# Economic and Social Council

## **Proposal for Supplement 4 to the 03 series of amendments to UN Regulation No. 129 (Enhanced Child Restraint Systems)**

### **Submitted by the Working Party on Passive Safety \***

The text reproduced below was adopted by the Working Party on Passive Safety (GRSP) at its sixty-fifth session (ECE/TRANS/WP.29/GRSP/66, para. 40). ECE/TRANS/WP.29/GRSP/2019/35, as amended by Annex VIII to the report. It is submitted to the World Forum for Harmonization of Vehicle Regulations (WP.29) and to the Administrative Committee (AC.1) for consideration at their June 2020 sessions.

Figure 2  
ECRS Measurement Device - Side and Front View of the measuring device

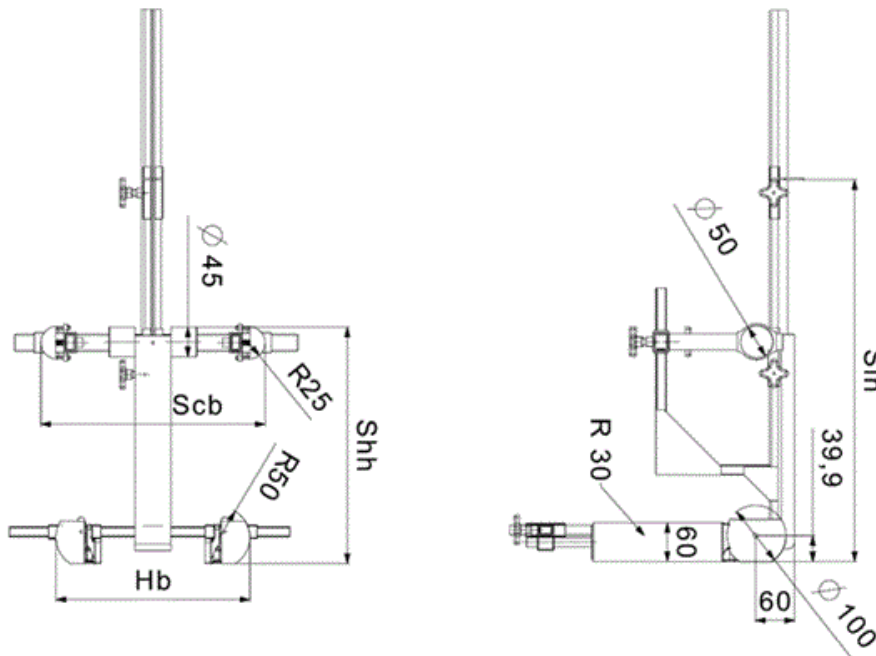
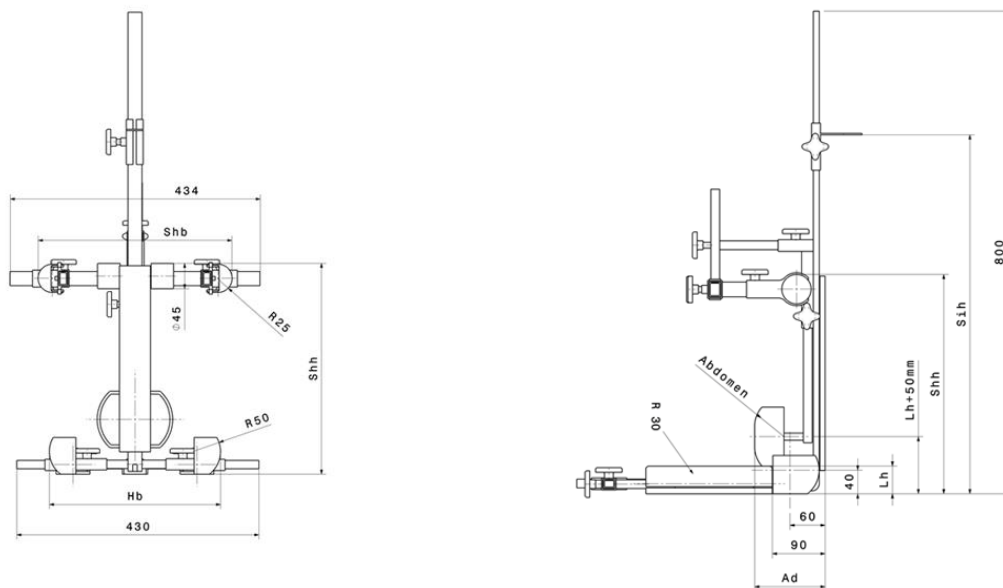
Annex 18., amend to read:

For integral or non-integral ECRS the device shown in Annex 18, Figure 2 shall be used.

The mass of the devices described in Figure 2 and Figure 3 shall be 10 kg +/- 1 kg.

All measurements shall be taken with the device base in contact with the seat pan of the ECRS and the device backrest in contact with the backrest of the ECRS. All lateral dimensions shall be measured under a contact force of 50 N with the devices described in Figure 2 and Figure 3 of this annex.

Figure 3  
Side and Front View of the measuring device for measurements applicable to Enhanced Child Restraint Systems that feature an impact shield

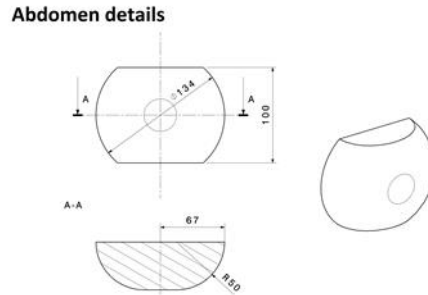
For ECRS with an impact shield the device shown in Annex 18, Figure 3 shall be used.
